## Procedure for Repositioning IS5100Z Hydro Drive Spring

## Product Information Notice # 70

Figure 1. Inspecting the Idler Arm

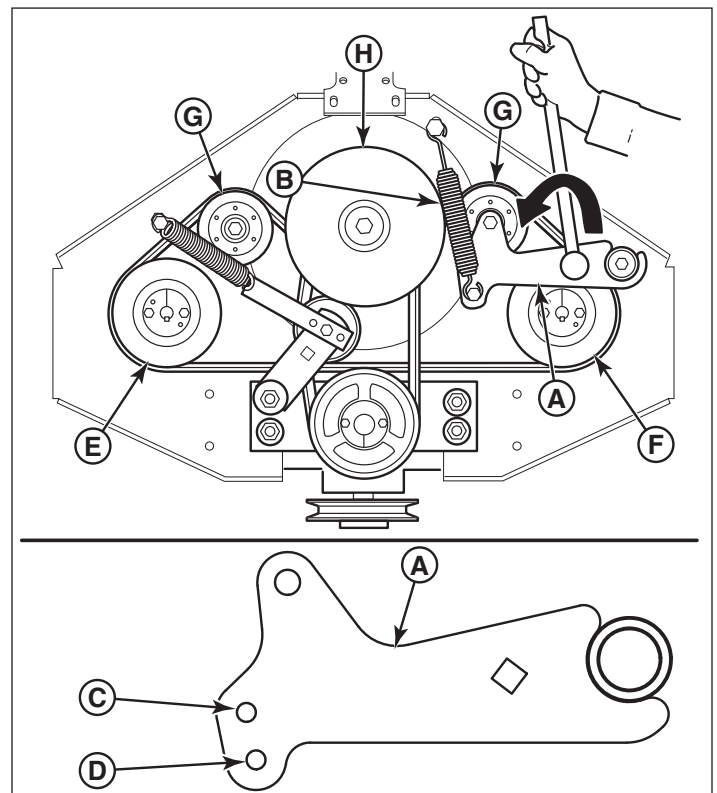
1. Park the zero-turn rider on a smooth, level surface such as a concrete floor. Disengage the PTO, engage the parking brake, turn the ignition switch to OFF, and remove the ignition key.
2. Release the hood latch, raise the hood, and secure in the open position.
3. Remove the rear belt shield.
4. Observe the hydro drive idler arm (**A, Figure 1**) and tensioning spring (**B**).
5. There are two spring mounting holes in the hydro drive idler arm:
  - If the spring is installed in the **upper hole (C)** of the hydro drive idler arm, the spring is **not installed correctly**, perform the *Correction* procedure.
  - If the spring is installed in the **lower hole (D)** of the hydro drive idler arm, the spring is **installed correctly** continue with step #6.
6. Re-install the rear belt shield and lower the hood. Make sure the hood is firmly latched.

1. Using a 1/2" breaker bar, place the square end in the square hole located in the idler arm (**A, Figure 1**). Carefully rotate the breaker **counter-clockwise** which will relieve the tension on the belts exerted from the idler arm.
